Intel® Pentium® Processor N3500-series, J2850, J2900 and Intel® Celeron® Processor N2900-series, N2800-series, J1800-series, J1900, J1750

Specification Update

April 2019

Figure 65. SPI NOR Timing

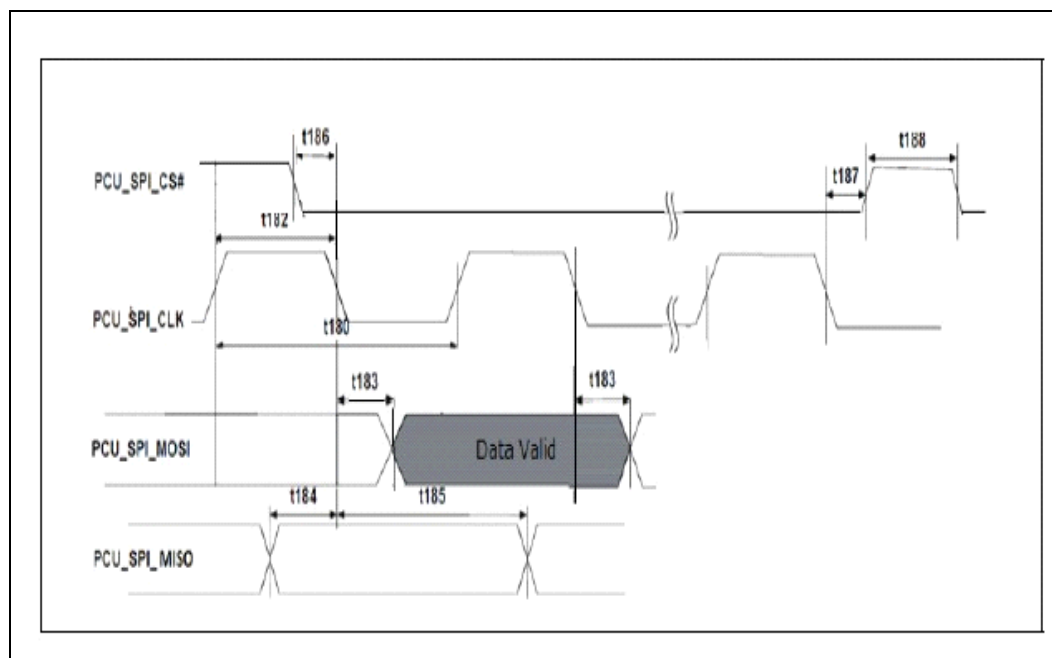
The setup of PCU_SPI_MISO with respect to serial clock falling edge at the host (t184) as stated in Table 131 PCU-SPI NOR AC Specification, of Section 9.6.18 PCU SPI NOR AC Specification, is listed as 11ns (min). After re-checking post validation and simulation data, the value of t184 can be revised down to 6ns (min).
